02635 Version 2

Safety Recall: Rear Grab Handle Brackets

This bulletin supersedes S/B 15-079, dated October 23, 2015, to include the Repair Procedure, Parts Information, and Warranty Claim Information

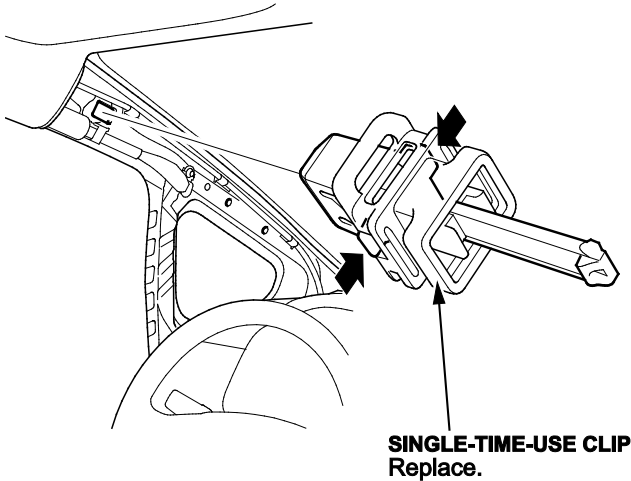
2. Replace the rear grab handle brackets and torque the bolts to **4.4 N·m (3.2 lb-ft)**.

NOTE: Make sure you install the new grab handle brackets in the correct direction.
